Wisconsin Department of Transportation

**Proposal #13: 1693-32-74, WISC 2018 143
Cross-Town Connector Bridge
Over STH 100
Non-Hwy
Milwaukee County**

This is Addendum No. 01, which provides for the following:

ADDENDUM NO. 01

Addendum No. 01
 ID 1693-32-74
 Revised Sheet 21
 March 12, 2018

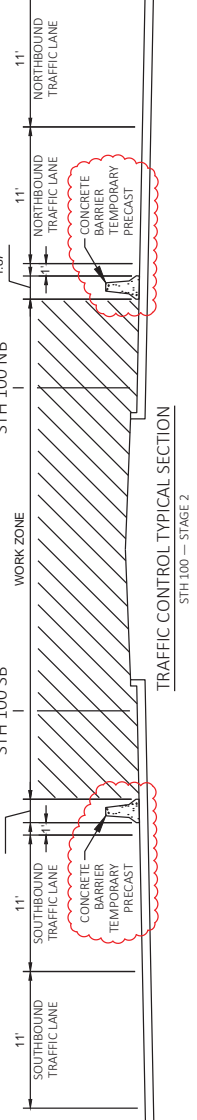
Revised Plan Sheets	
Plan Sheet	Plan Sheet Title (brief description of changes to sheet)
21	Traffic Control Stage 2 – Added Concrete Barrier Temporary Precast to protect median during bridge pier construction
47	Miscellaneous Quantities – Added additional quantity for Item 603.8125 Concrete Barrier Temporary Precast Installed, added SPV.0060.07 Utility Line Opening
49	Plan & Profile – Labeled utility lines with name of owners
50	Plan & Profile – Labeled utility lines with name of owners
